STATE OF MAINE
DEPARTMENT OF TRANSPORTATION
☐ Approved
☐ Returned for Corrections
AUG 2[illegible] 1997
☒ Approved as noted
☐ Rejected

PROJ. NO. : BH-043-1(34)
ITEM NO. : 520.22

PROJECT: JOSHUA CHAMBERLAIN BRIDGE OVER THE PENOBSCOT RIVER, BANGOR-BREWER, ME

EXPANSION JOINT DETAIL @ PIER 1

SECTION A-A

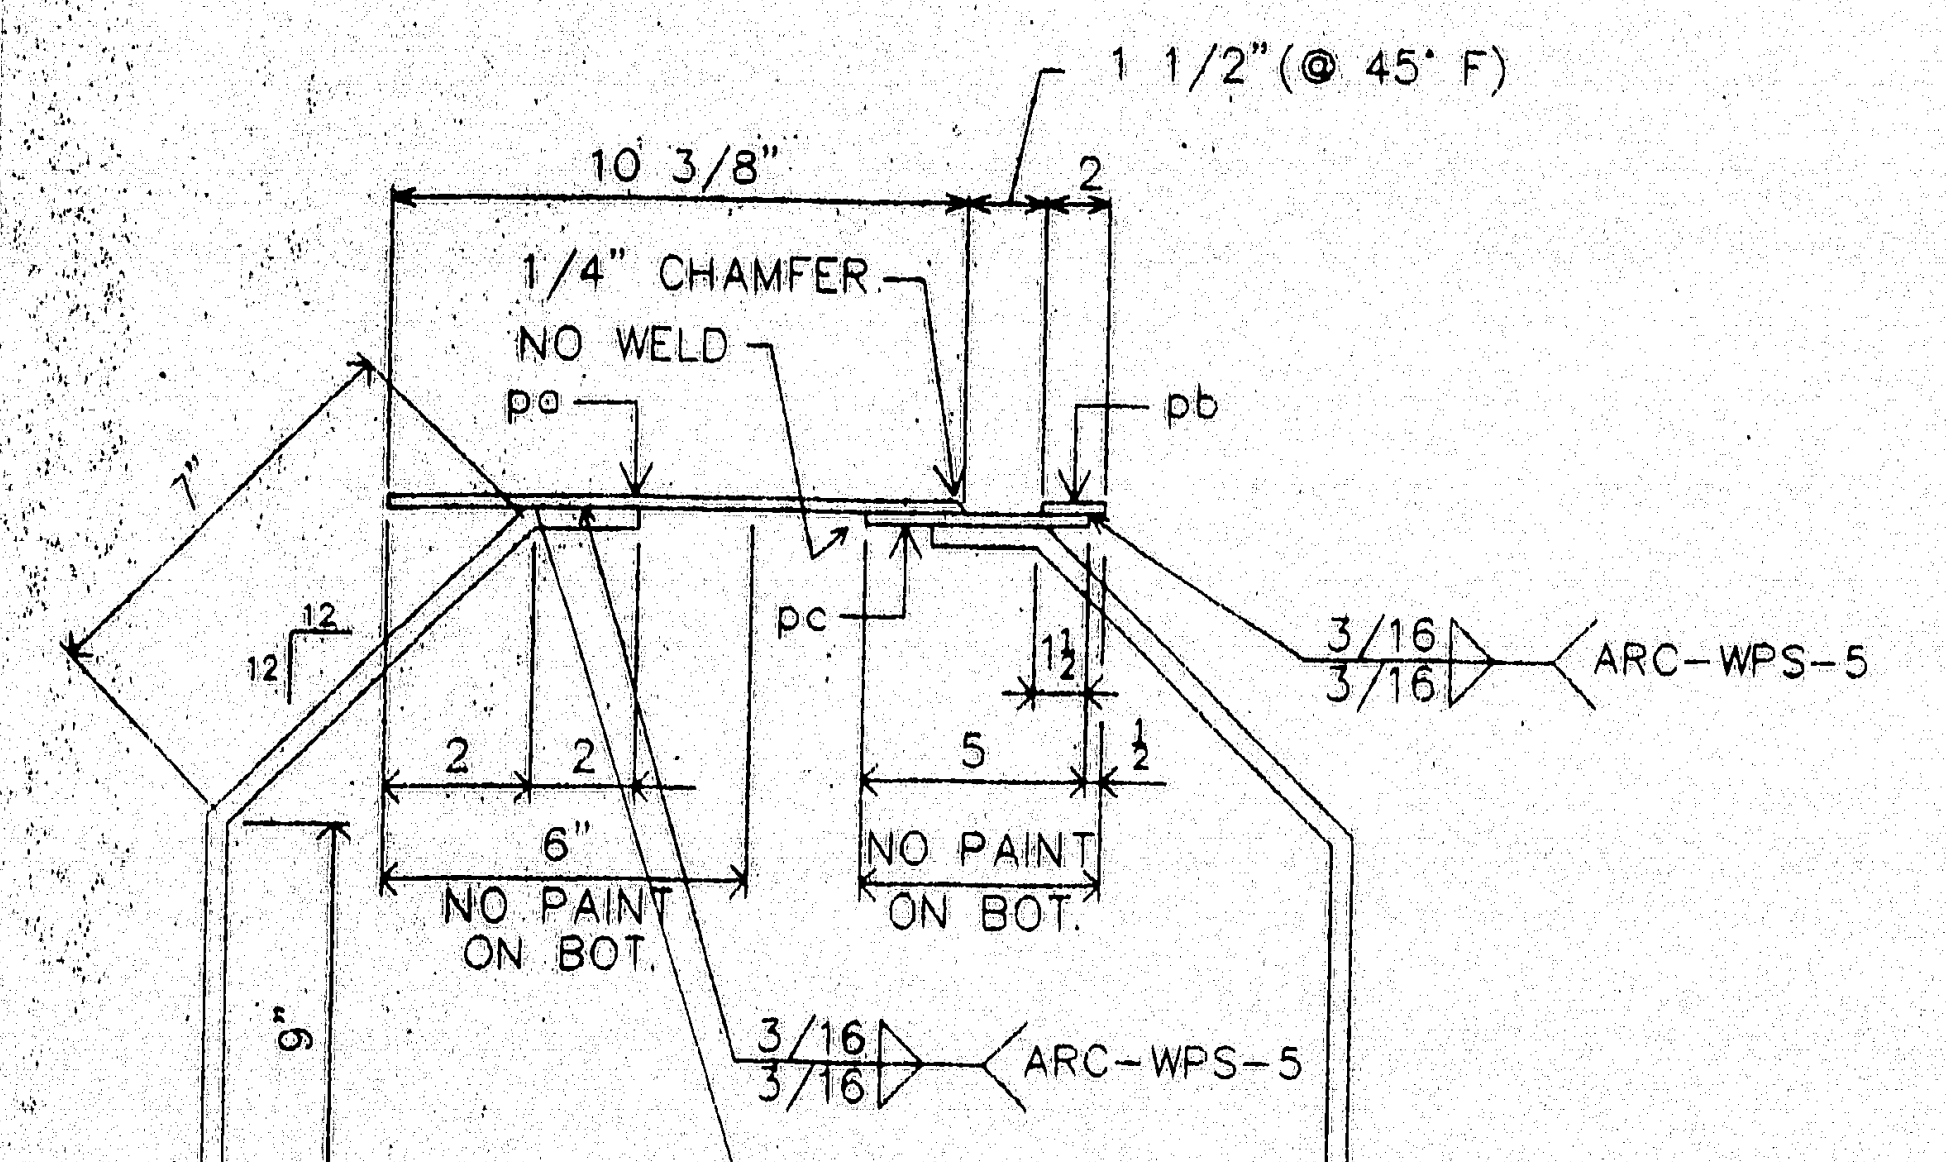
X-tra Work

MATL: A36 UN HOLES: AS NOTED
WELD: PER PROCEDURES NOTED
PREP: SP6
FINISH: ~~3 COATS ZINC RICH PRIMER~~
~~3 MDFT PER COAT~~

Prefered Option: Get Price for Galvanizing Assembly.

(or)

Select Paint System from Nepcoat List.

Typical Systems

1. Inorganic Zinc Primer.
2. 2 Part Epoxy.
3. Urethane Topcoat.

Carboline
Wasser
Keeler & Long
Valspar

DETAIL @ OUTER BAR STOP

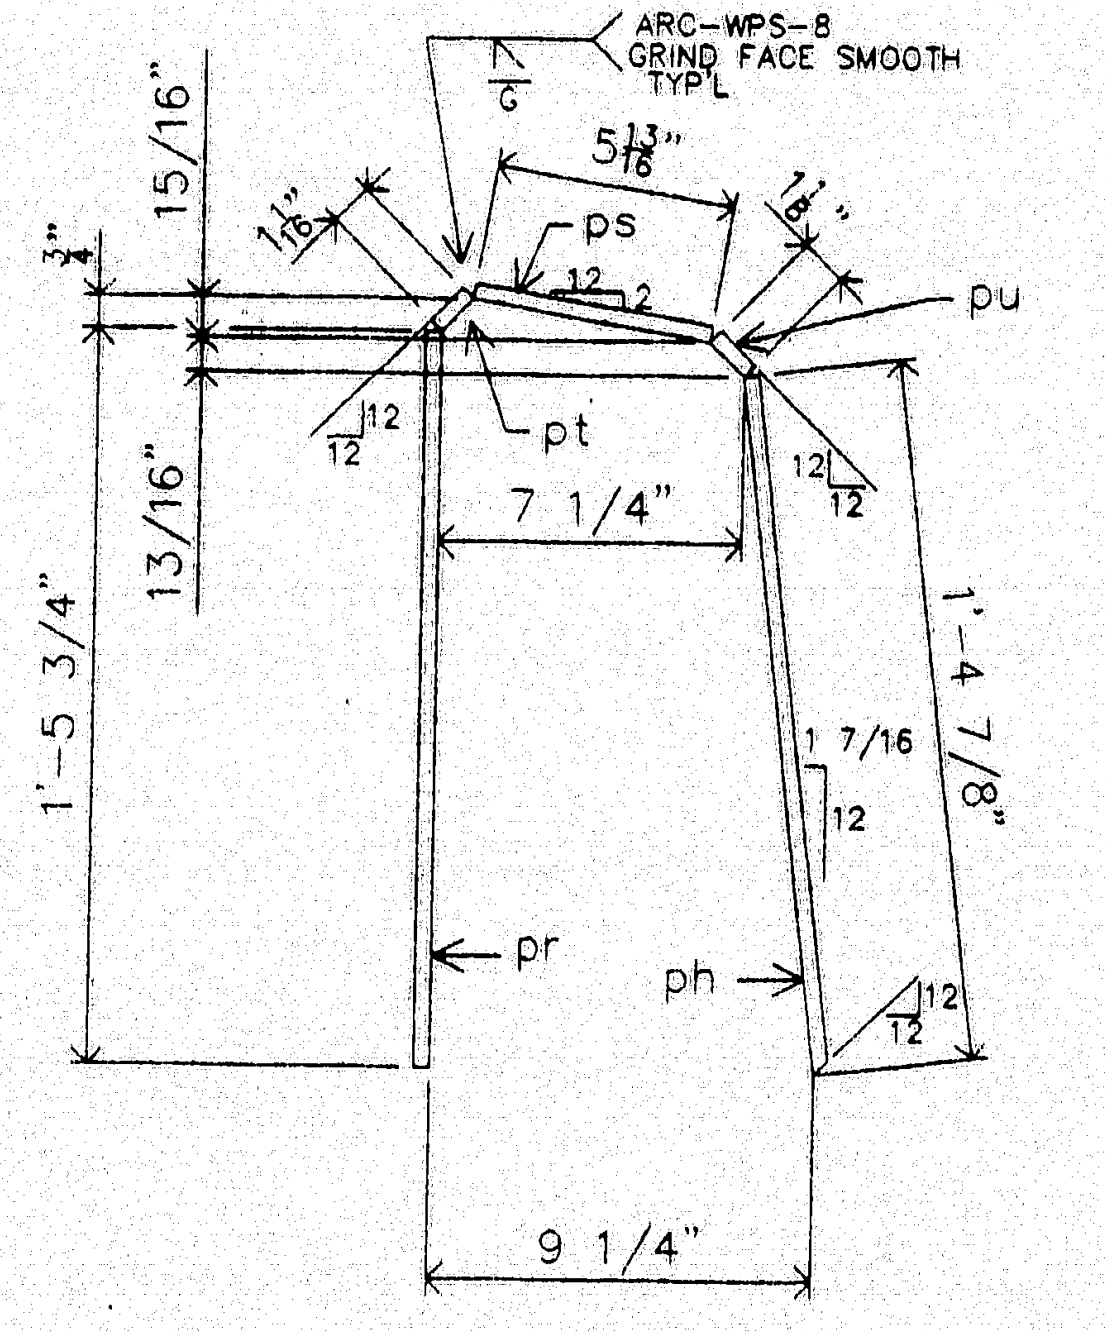
Submit WPS for this weld including elevated temperatures requirements for welding Reinforcing Steel AWS D1.4.

(or)

Substitue a flatbar of appropriate size and strength and use an existing fillet WPS.

EXPANSION JOINT DETAIL @ HINGE SPAN 7

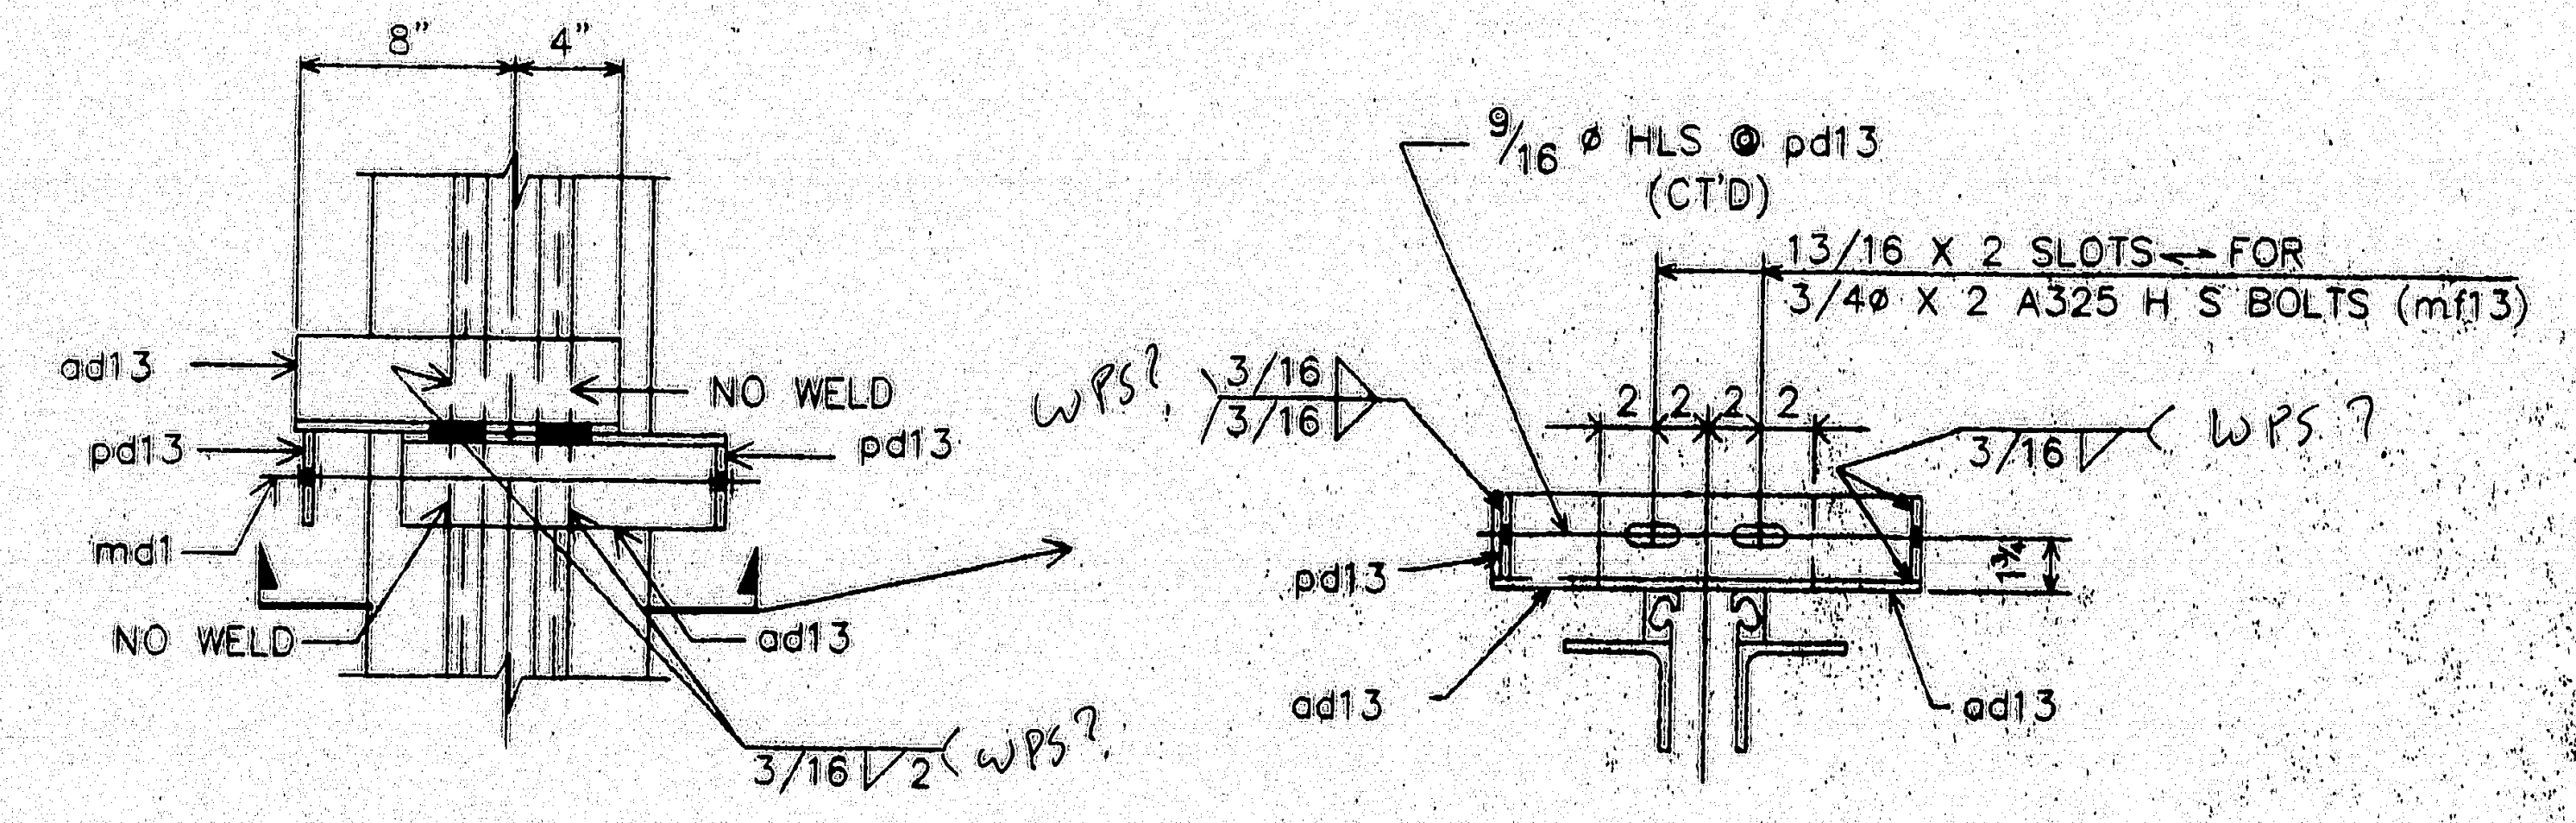
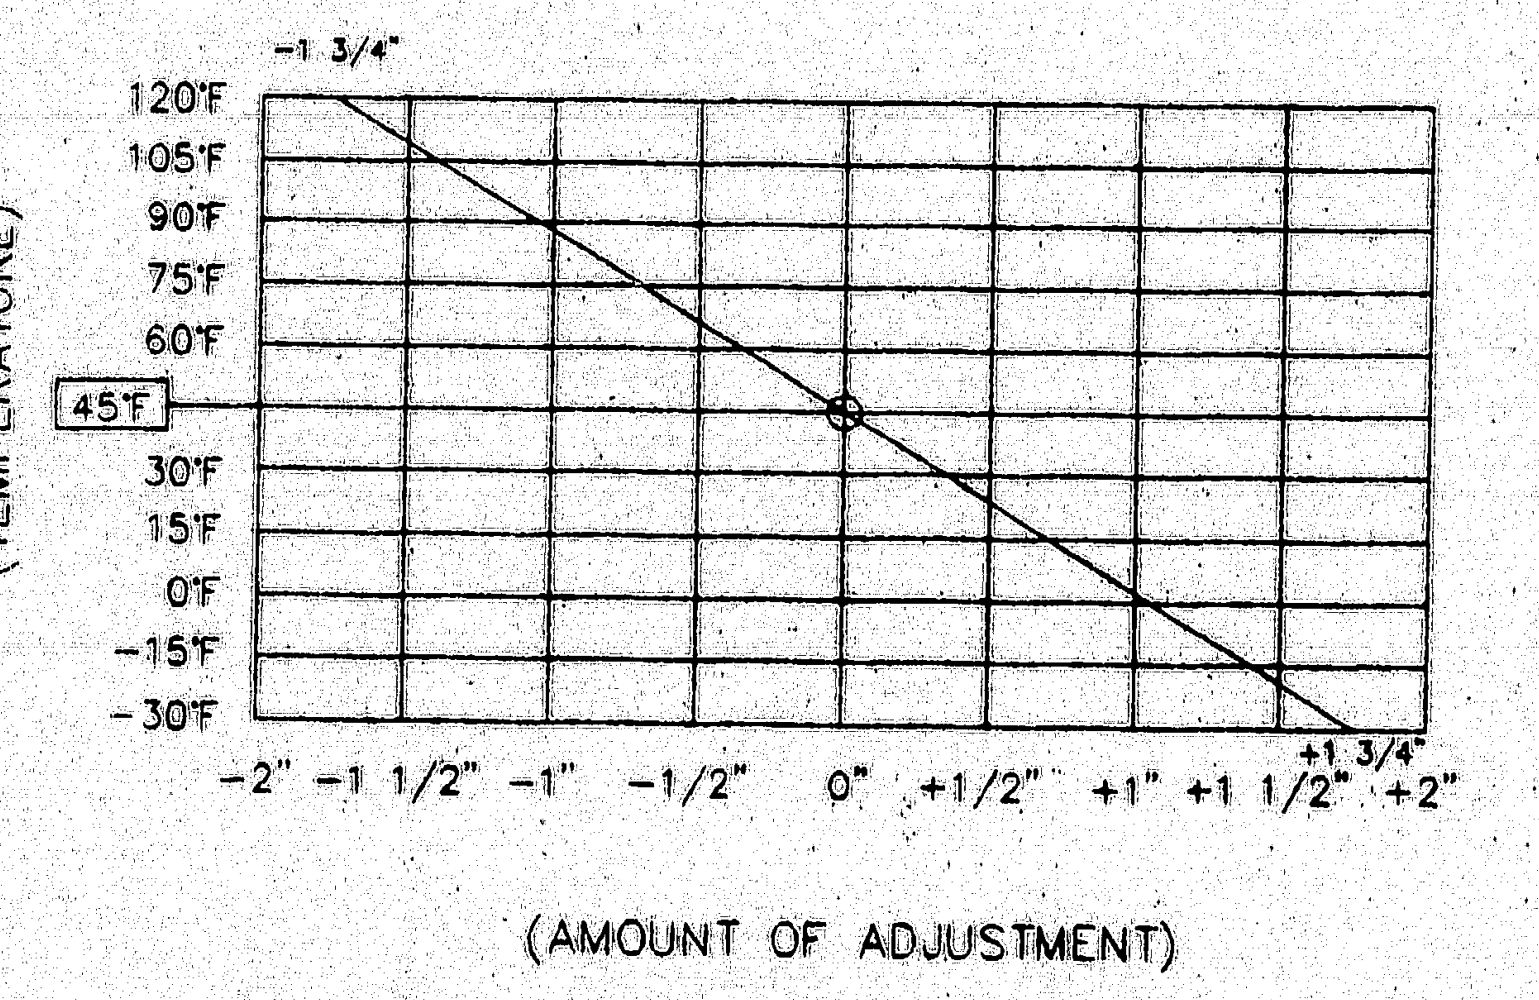
MAT'L: A36 UN
HOLES: AS NOTED
WELD: PER PROCEDURES NOTED None Noted
PREP: SP6
FINISH: 3 COATS ZINC RICH PRIMER
3 MDFT PER COAT

2 coats OK.

SCALE: ~	APPROVED BY:	DRAWN BY: BB	
DATE: 7/97		CHKD. BY:	
EXPANSION JOINT @ HINGE SPAN 7			
REED & REED		JOB NO. 97-49	DWG. NO. 13

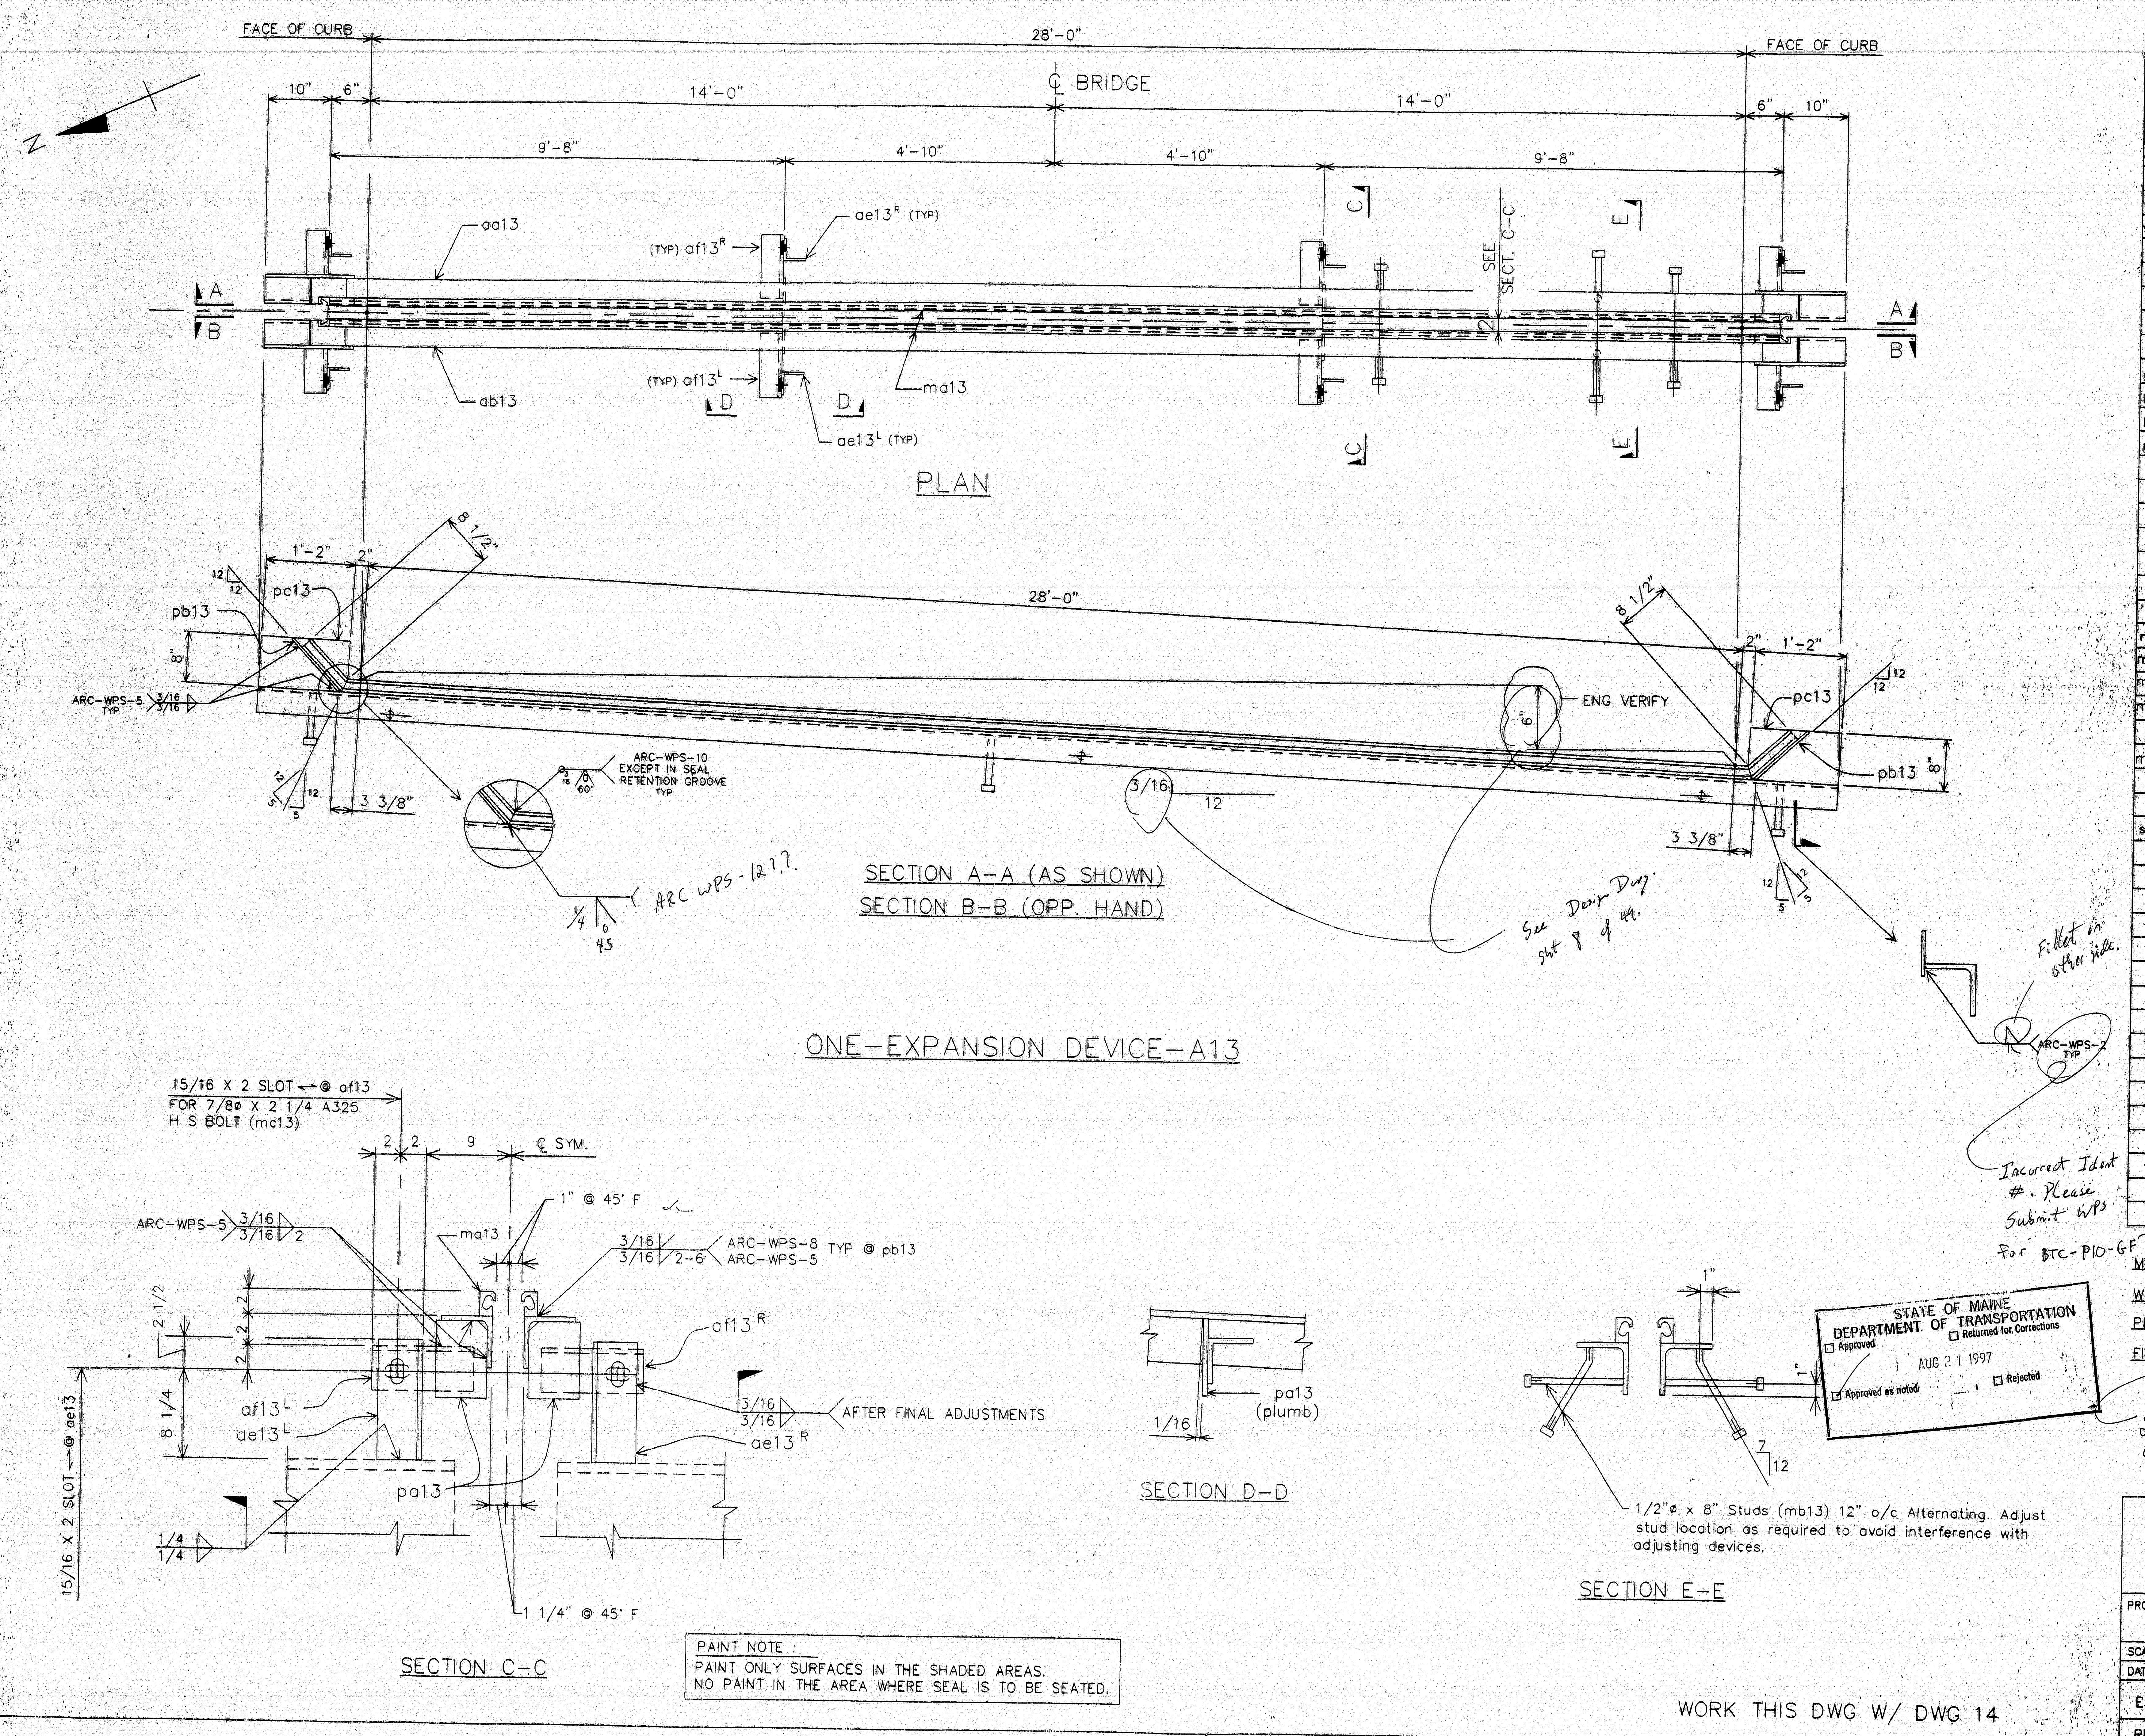
Incorrect Ident #. Please Submit WPS for BTC-P10-GF2.

MATL: A36 UN
HOLES: AS NOTED
WELD: PER PROCEDURES NOTED
PREP: SP6
FINISH: 3 COATS ZINC RICH PRIMER
3 MDFT PER COAT

2 Coats is sufficient.
